M^CLAREN TRAFFIC ENGINEERING

Reference: 190226.05FA

LETTER OF RESPONSE TO COUNCIL CONCERNS FOR PROPOSED LEISURE AND ENTERTAINMENT PRECINCT AT WARLTERS STREET & PARK STREET, PORT MACQUARIE

FIGURE 1: MTE TRAFFIC DISTRIBUTION – WARLTERS STREET UPGRADE

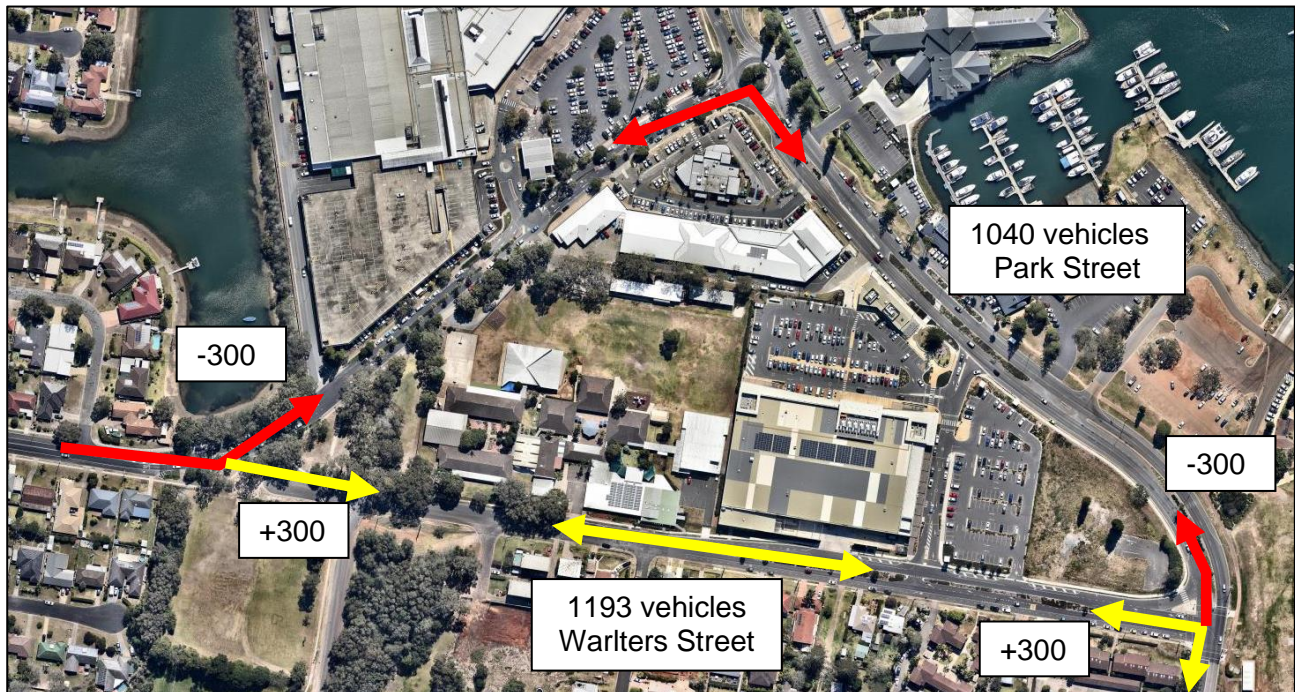
Warlters Street will ultimately become a thoroughfare. The Council engineers are not satisfied that this future thoroughfare has been taken into account in the traffic analysis. They are concerned that the proposed right-hand turning aisle is too short and will result in vehicles backing up at the Park Street and Warlters Street signalised intersection, causing trouble there.

MTE Response: Port Macquarie-Hastings Council completed a Traffic Study for their LGA in October 2019. Within this report the Council lists a series of localised urban works which includes the upgrade of Bay Street / Warlters Street / Aston Street to a roundabout in order to *improve access to the Settlement City area*. MTE accepts that this treatment will increase through traffic along Warlters Street and will provide a more efficient route for vehicles traveling between the west along Bay Street and the south along Park Street.

It is important to note that the Council's Traffic Study does not provide detail about the expected future volumes along Warlters Street. Based upon the surrounding road network and the paths to and from the Settlement City Area, MTE has conservatively assumed that there will be an additional 600 bidirectional vehicles along Warlters Street. This would result in the redirection of traffic according to **Figure 1**.

The basis of this assumption is that through traffic on Park Street and Warlters Street will be similar in volume. MTE has assumed a slightly higher volume on Warlters Street, which is conservative given that Park Street provides access to a larger portion of the attractions within the Settlement City Area, specifically the existing shopping centre.

In the larger context, the connection of Bay Street and Warlters Street will not attract traffic other than traffic associated with the Settlement City Area (i.e. traffic between Port Macquarie and the Pacific Highway). Hastings River Drive and the Oxley Highway are the major roads connecting the Pacific Highway to Port Macquarie. The Warlters Street thoroughfare would be a significant detour for traffic not associated with the Settlement City Area or the few residential dwellings accessed from Warlters Street and Hastings Avenue.

ANNEXURE E: SITE PHOTOS – 25TH OCTOBER 2019

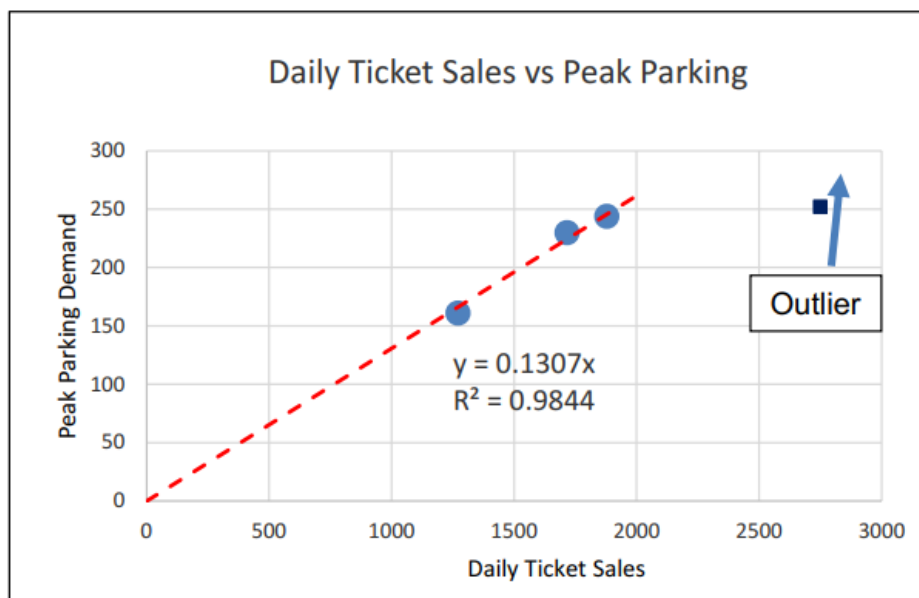
Patrick Galbraith-Robertson is not satisfied that sufficient parking to service the development is being provided within the basement and the Kmart parking area. Patrick believes that the revised traffic report still relies on on-street parking and parking in the Westport carpark.

Kmart closes at 7:00pm on Saturday evening. Therefore, a large amount of parking becomes available in the Kmart carpark during the Saturday PM period. Site photographs of a nearly empty Kmart car park at 8pm on 25th October 2019 are provided in **Annexure E**.

ANNEXURE G: PARKING SHORTFALL GRAPHS

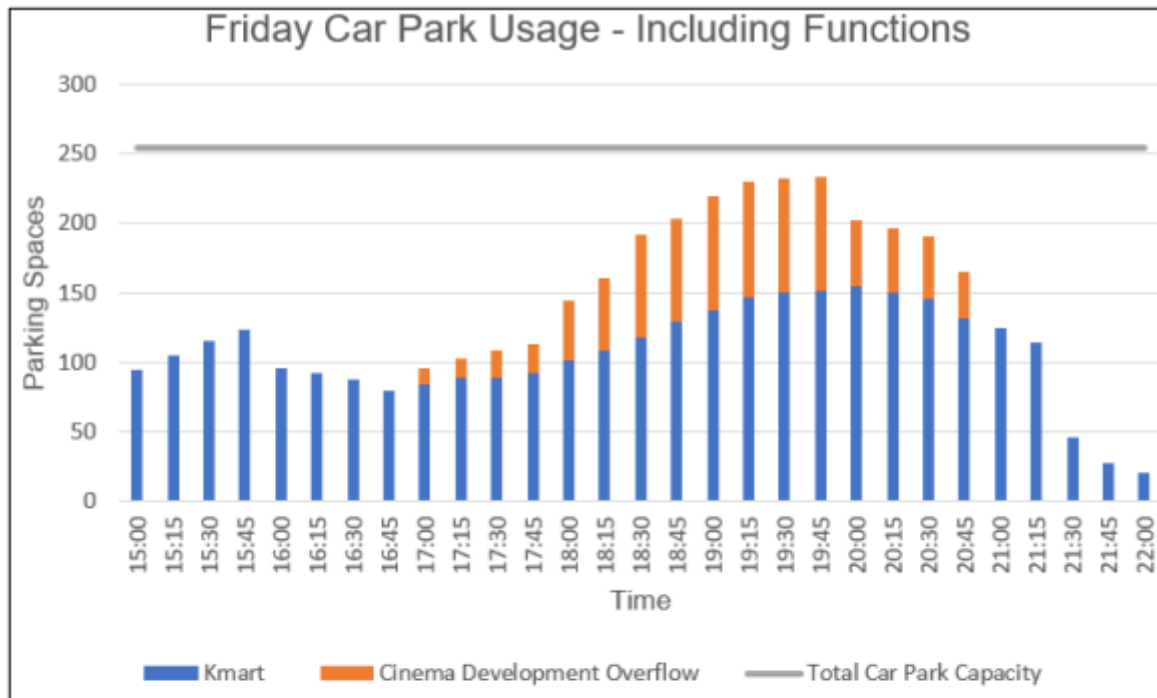
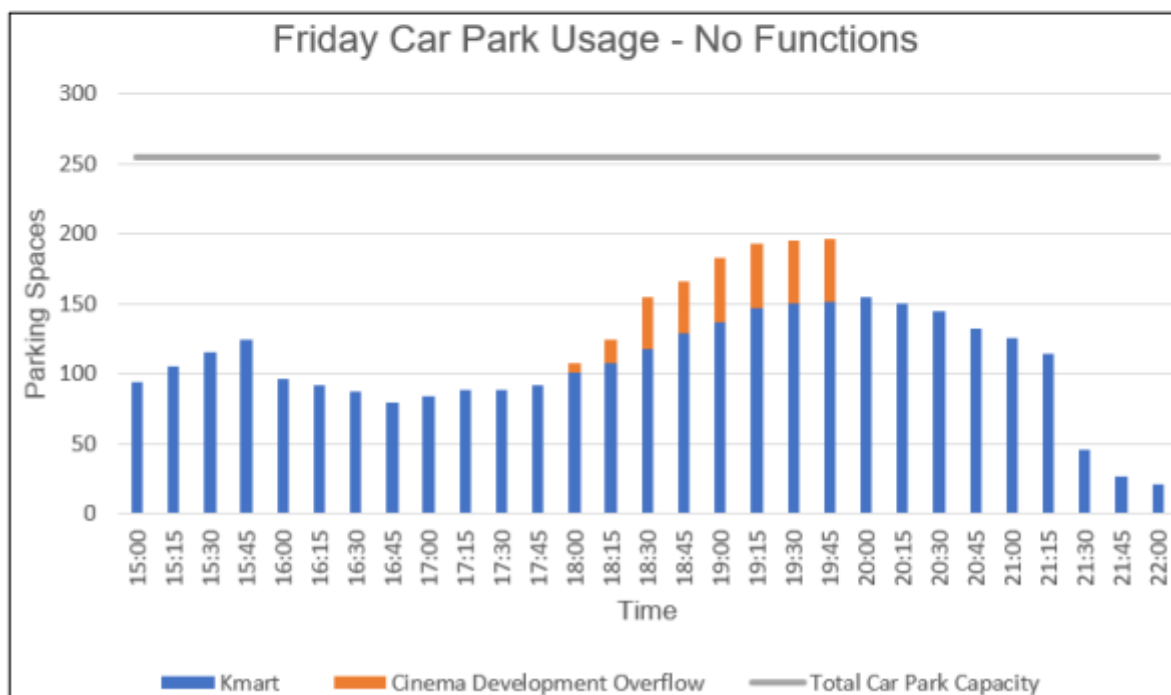
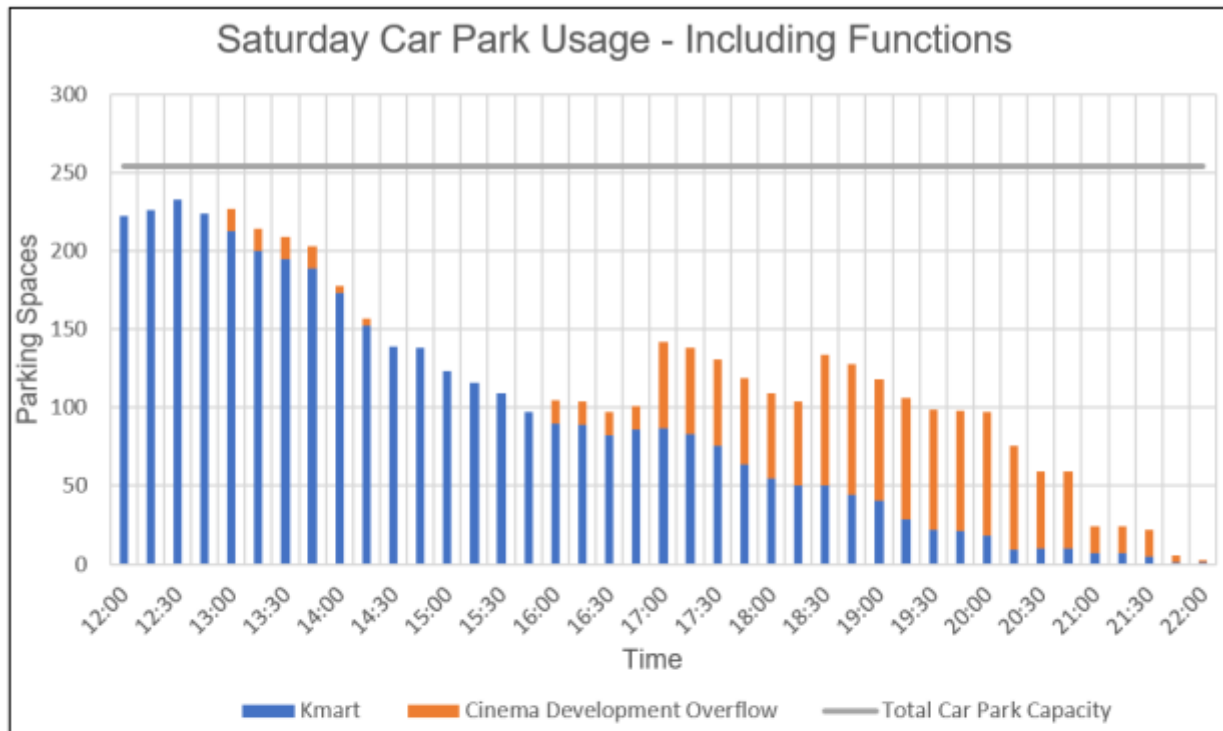
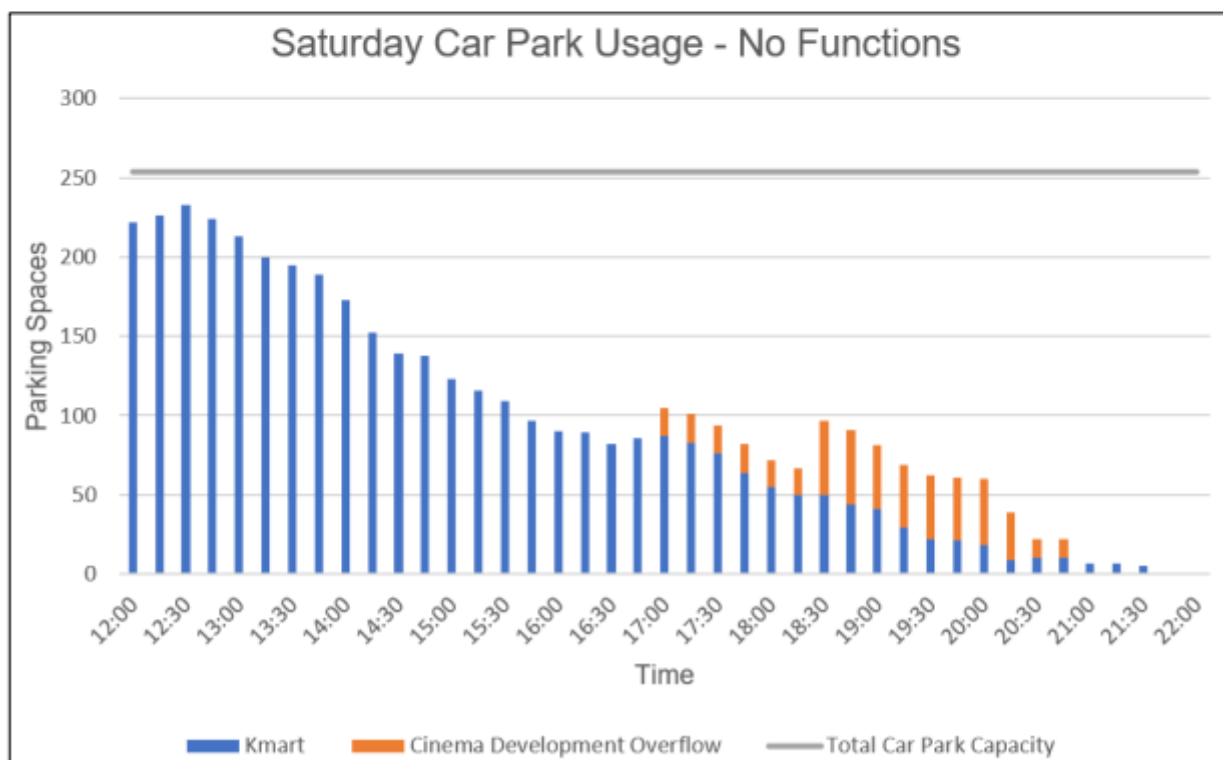
Patrick feels there is too much likely overlap of peak parking periods for the various proposed uses and that the combined peak periods for these various uses will result in a regular overall parking shortfall for the site.

MTE Response: A detailed parking profile was completed for the charts produced within the MTE Addendum Letter (ref: 190226.04FA). The profiles are based on (in order of availability) typical land use visitation profiles and reasonable estimation. The regular parking shortfall can be accommodated in the Kmart car park, both with and without functions occurring. The profiles are reproduced in **Table 5** and **Table 6**, resulting in the parking shortfall graphs shown in **Annexure G**.
